**ADDENDUM NO. 1****8/17/2022**

**RE:               McBurney Center Pool Renovation  
Corbin, Kentucky  
Project No. 21140**

**FROM:          Brandstetter Carroll Inc.  
2360 Chauvin Drive  
Lexington, Kentucky 40517  
Phone 859-268-1933  
Fax 859-268-3341**

## Pool Layout & Materials Plan

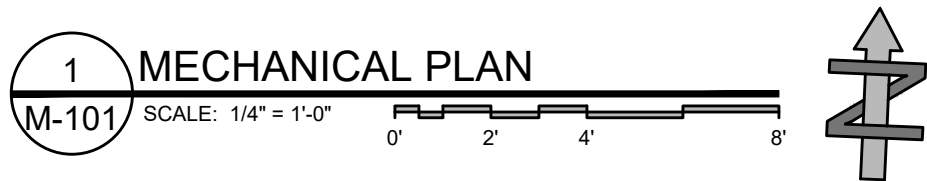
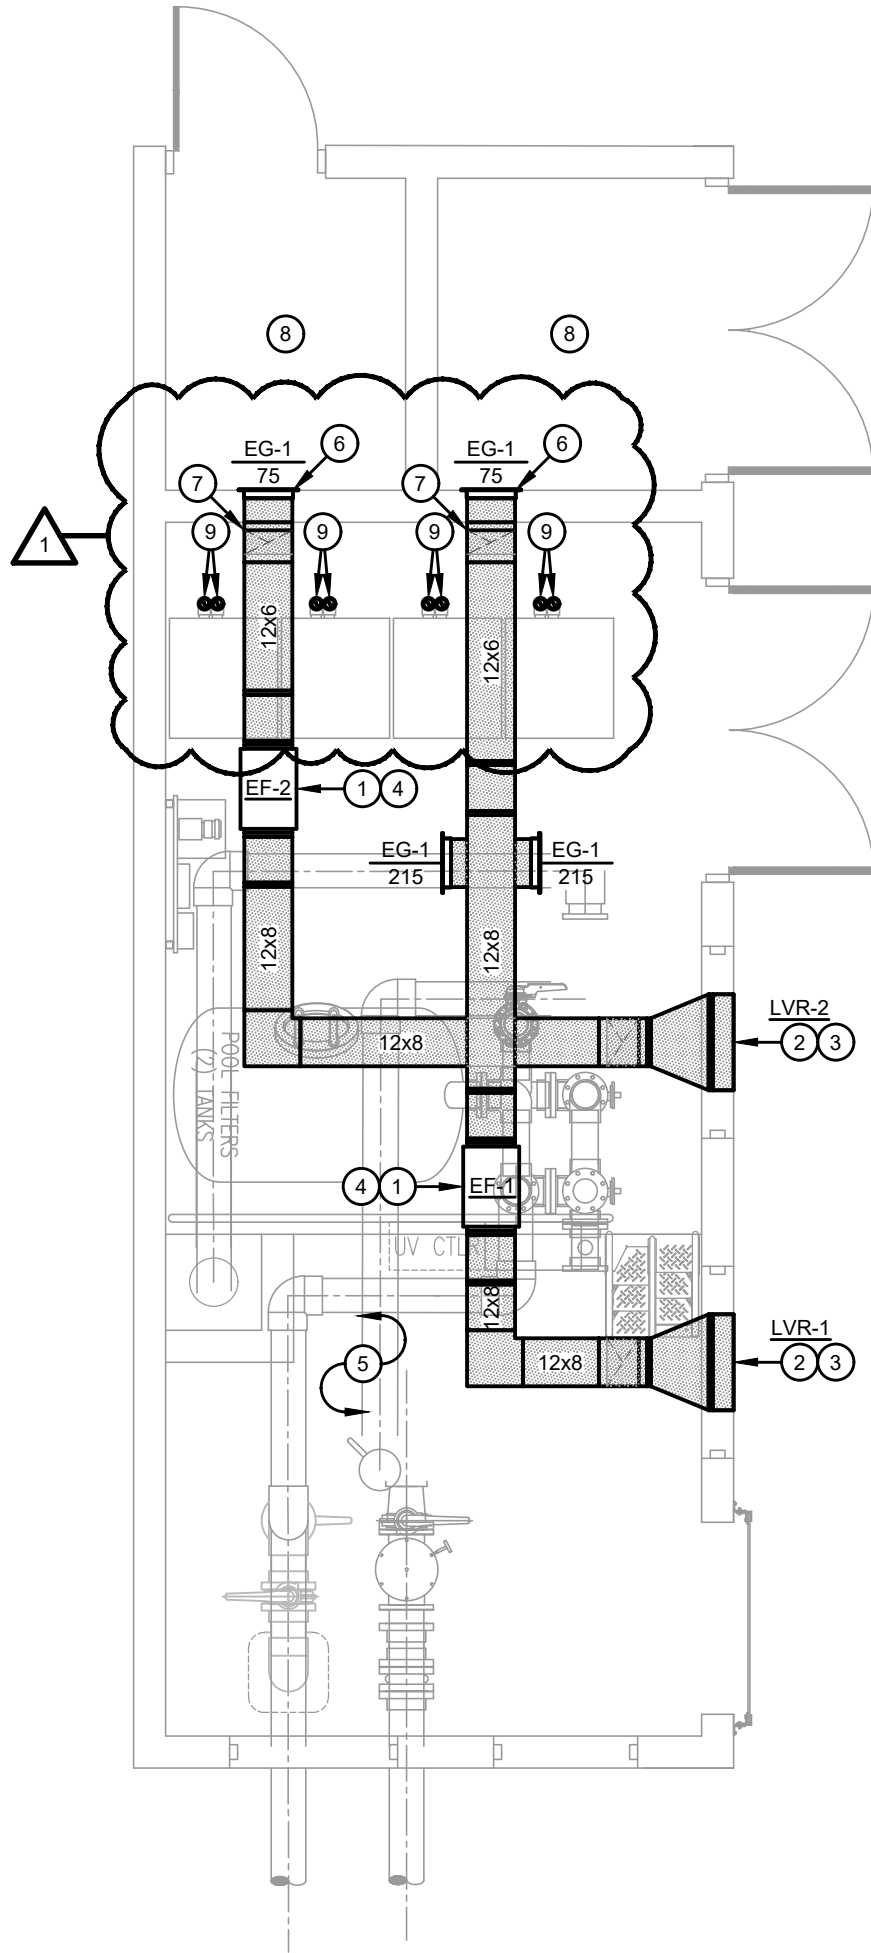
1. CP-102 – Pool Layout & Materials Plan
  - A. Added dome heaters to drawing to show their placement.
  - B. Added electrical outlets in deck to power the blowers for the dome heaters.
  - C. Added intake and discharge water lines for the dome heaters.
  - D. Added details to indicate the addition of American PermaHedge chain link fence privacy screening material to the new chain link fence around HVAC units only.
  - E. Added gate locations to the new 6'-0" fence around the facility.
2. CP-103 – Pool Dimensional Plan
  - A. Added dimensions locating water and electrical outlets for dome heaters.  
(These outlets are intended to only be used while the dome is in place).

Lighting & Power Plan

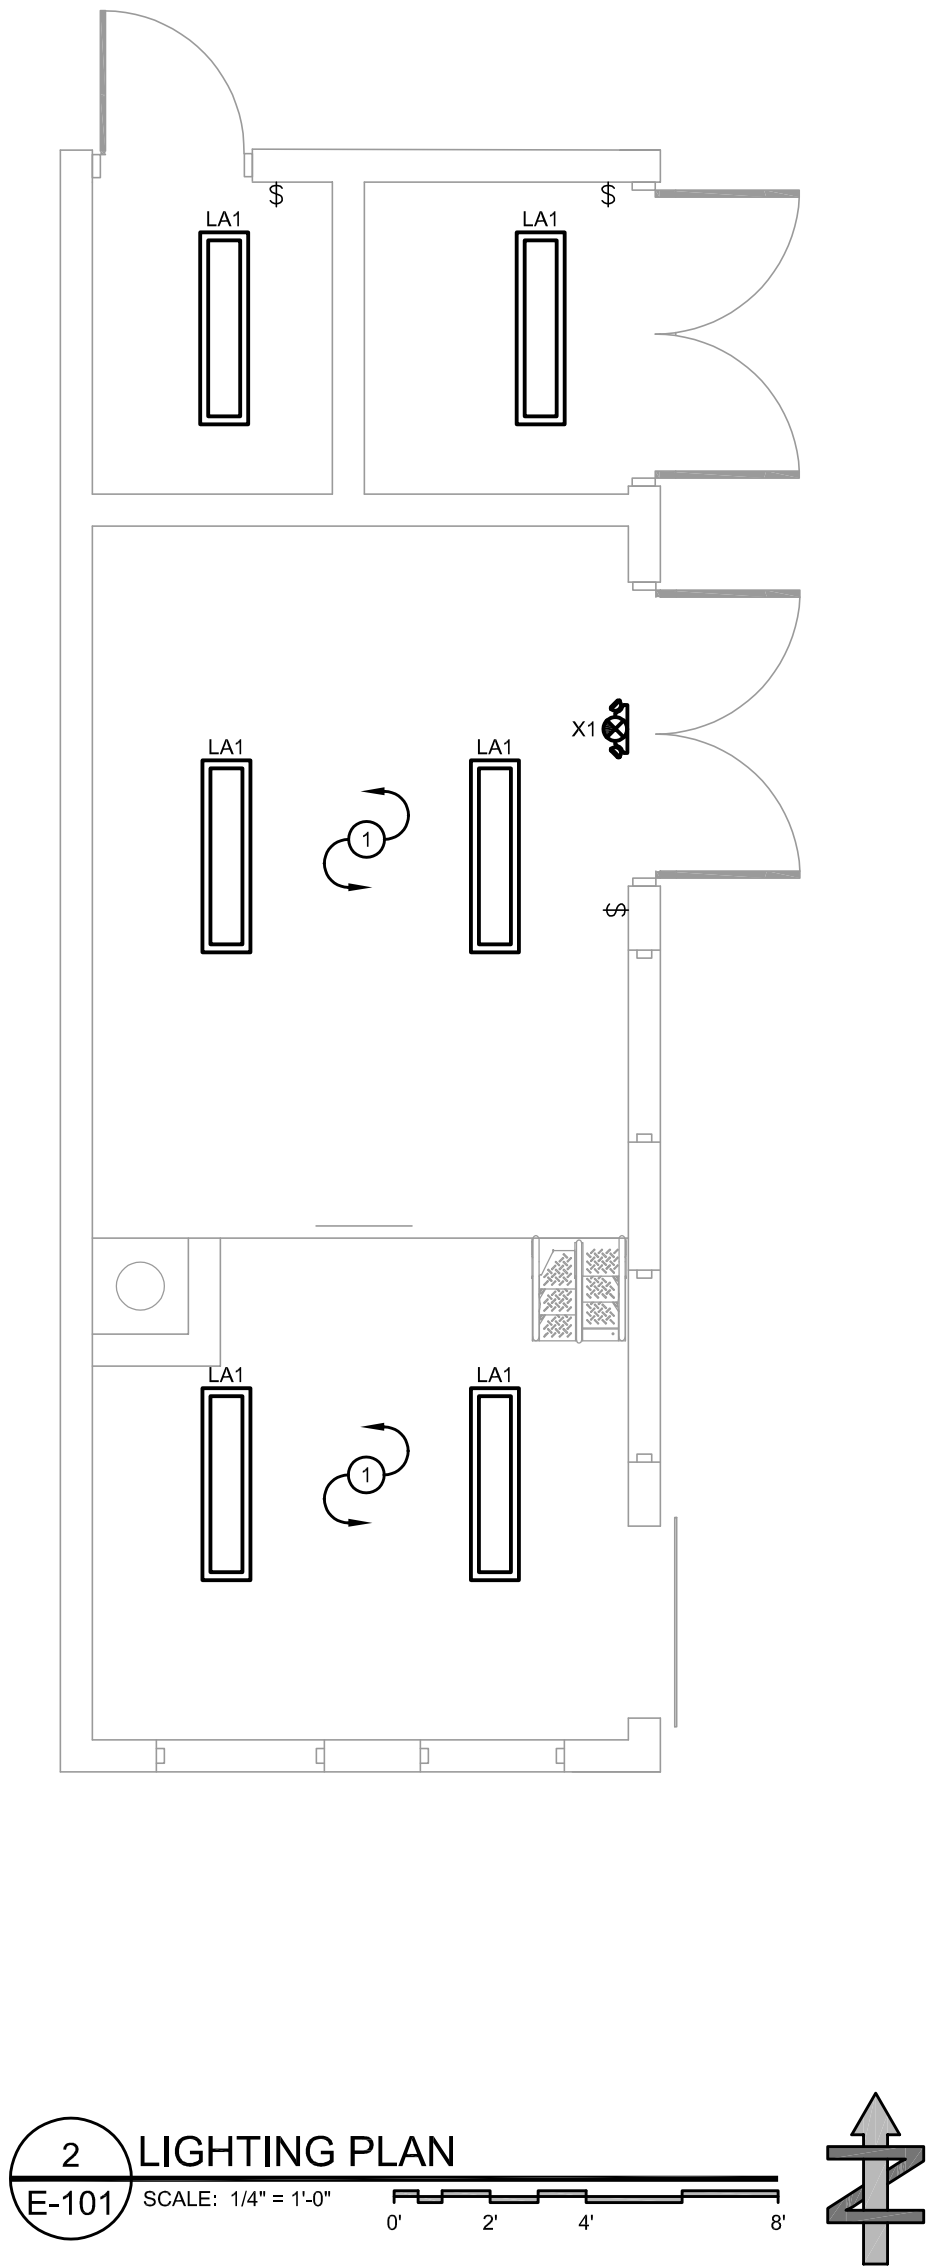
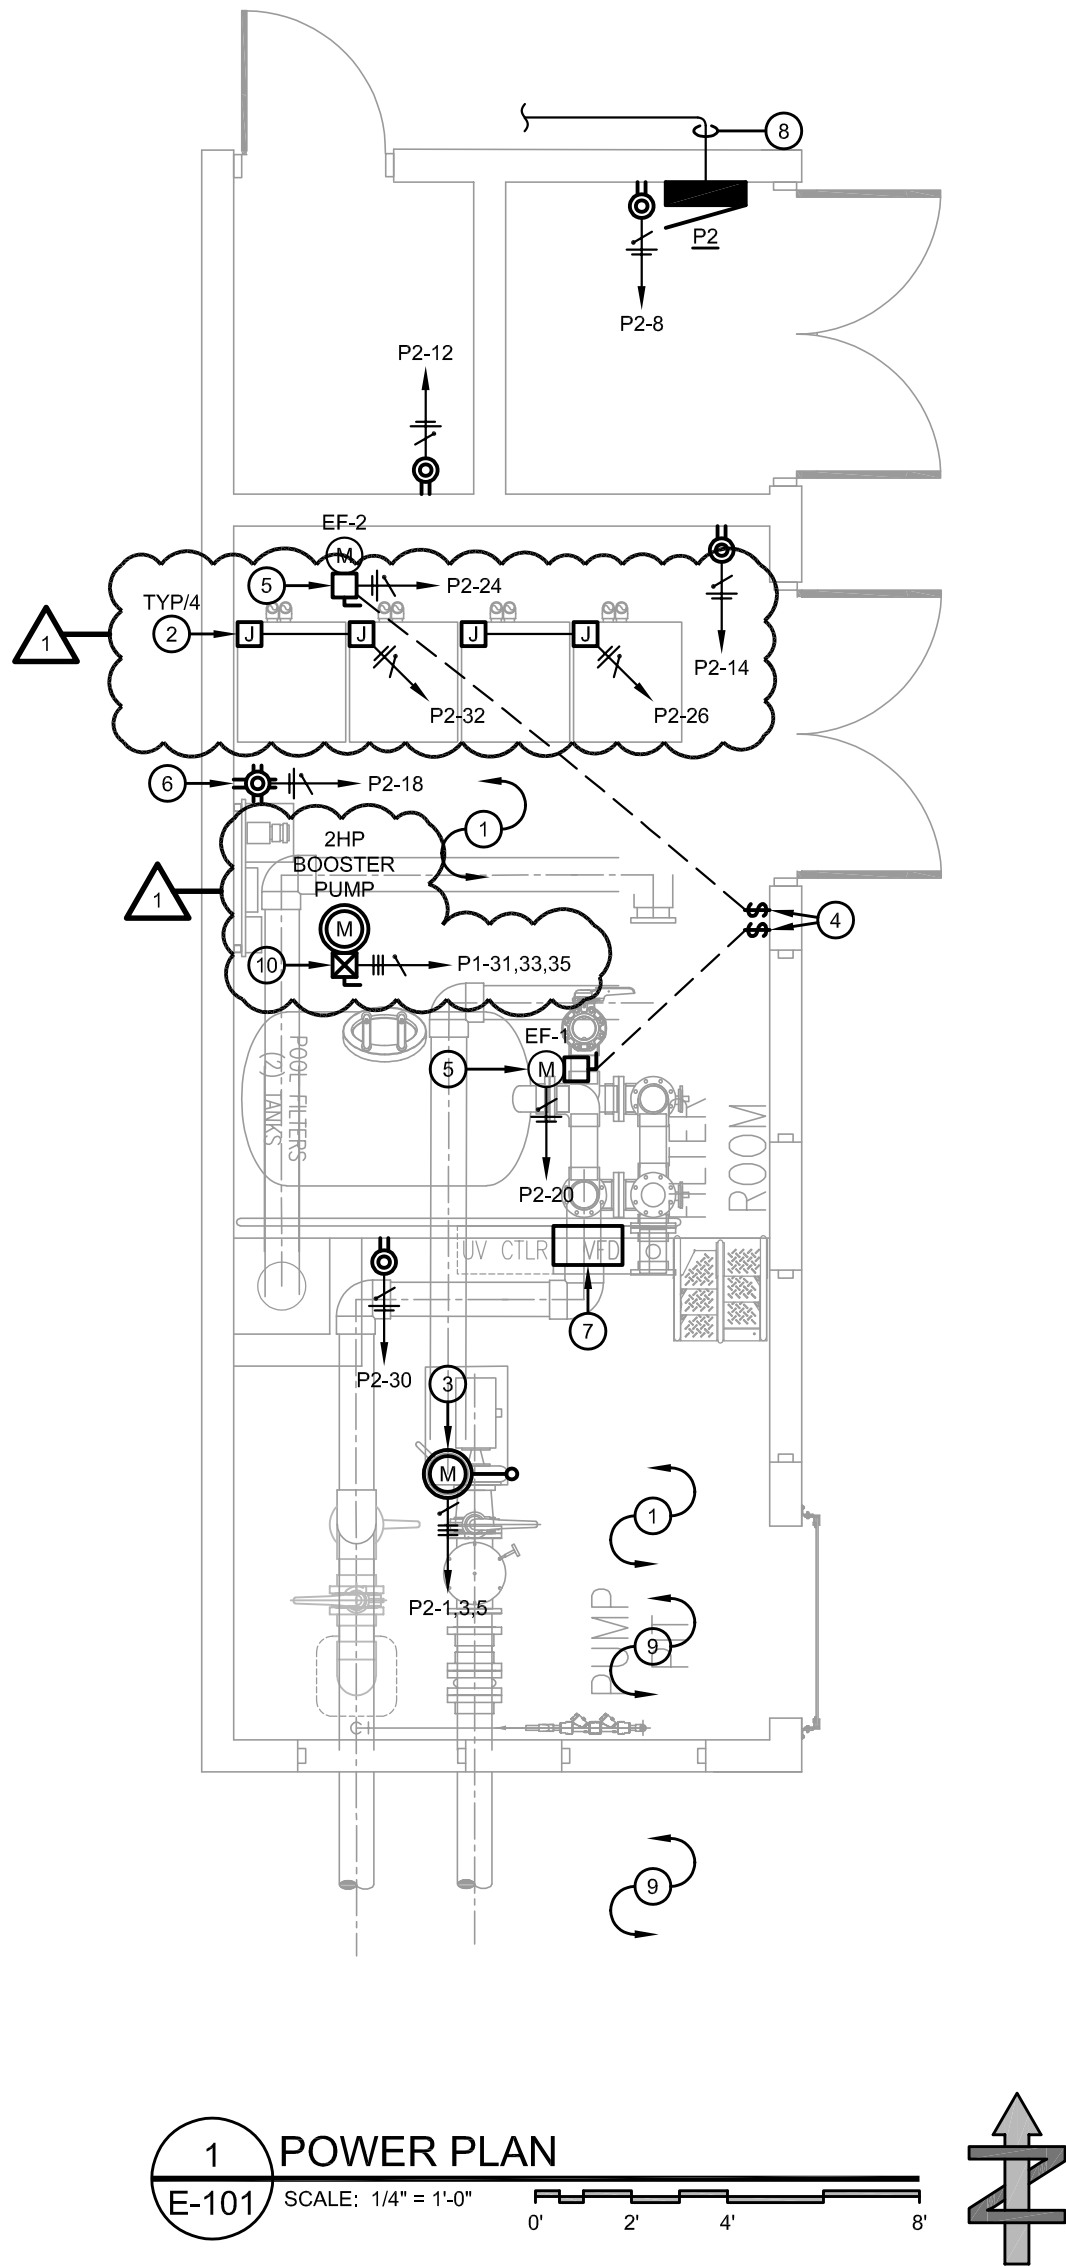
8. E-101 – Lighting & Power Plan
  - A. Added a booster pump to help pump water through the line that is feeding water to the dome heaters. (This pump will only be used when the dome is in use).

## CP-105 - Pool Deck Drainage & Utilities Plan

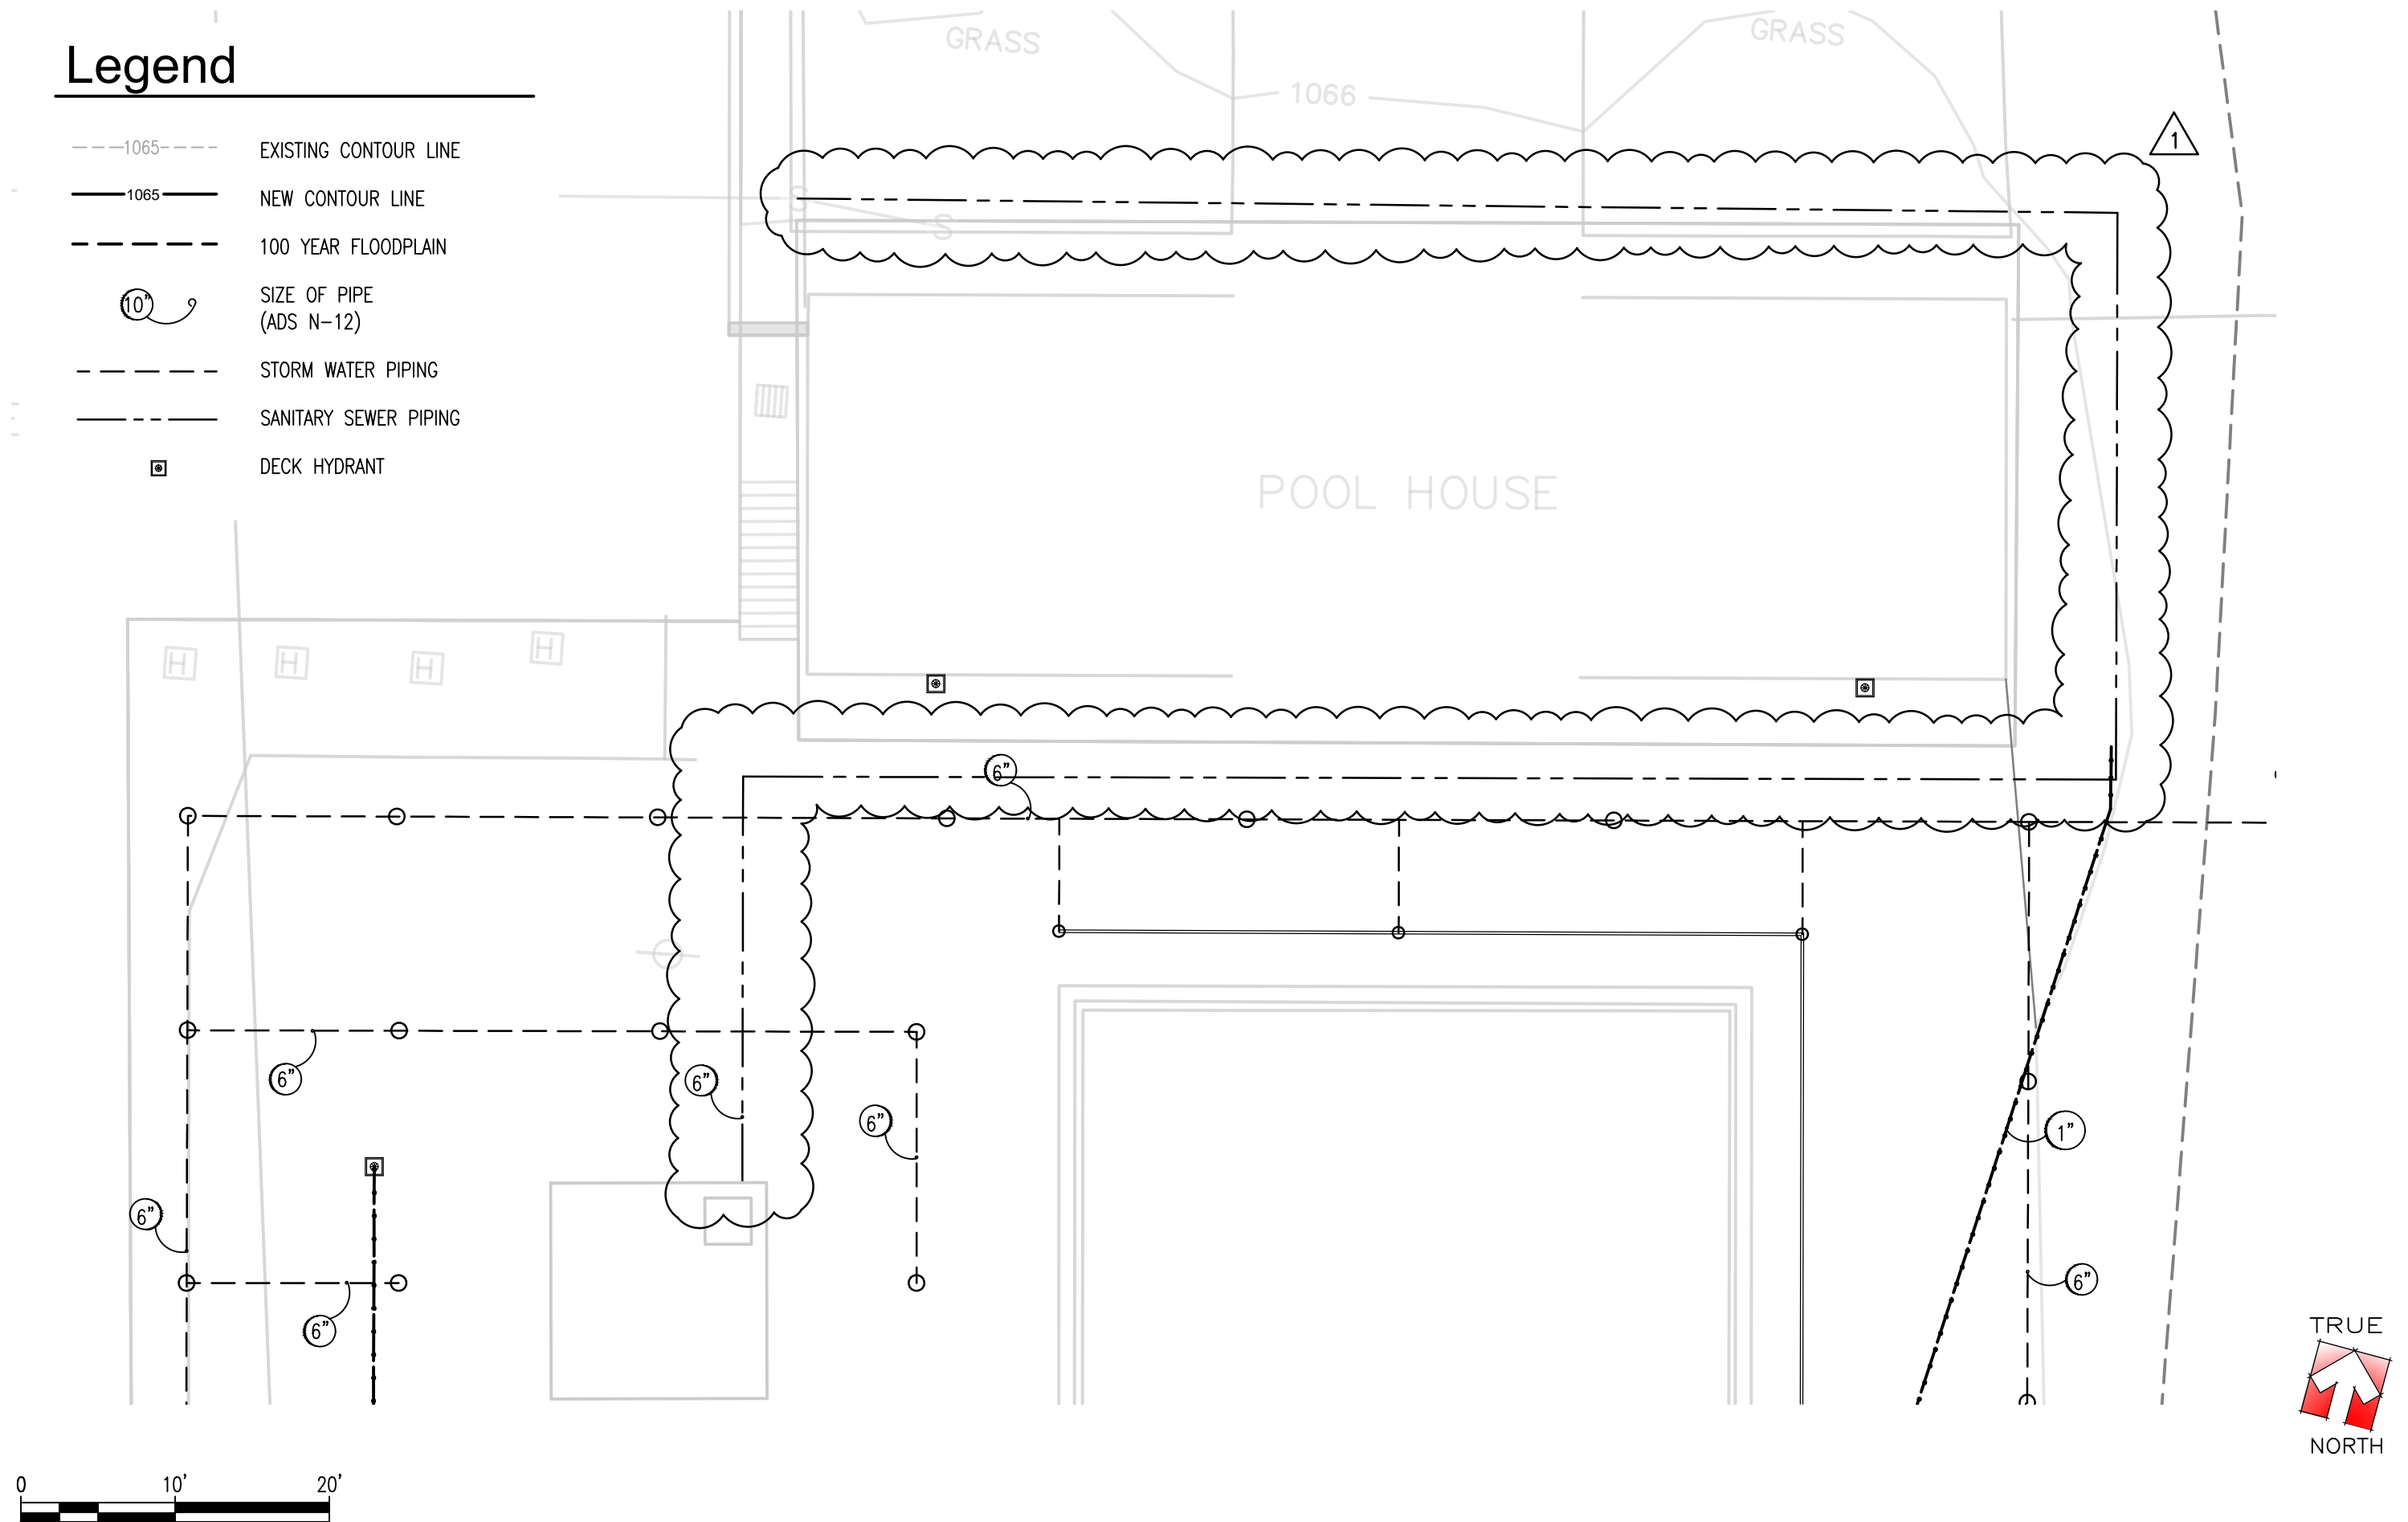
3. CP-105 – Pool Deck Drainage & Utilities Plan
  - A. Changed the drain line from the surge tank to be a sanitary sewer line.
  - B. Extended the sewer line to connect into the existing sewer line in front of the pool house. Grass and concrete will have to be excavated in front of the pool house to install new sanitary sewer lines.
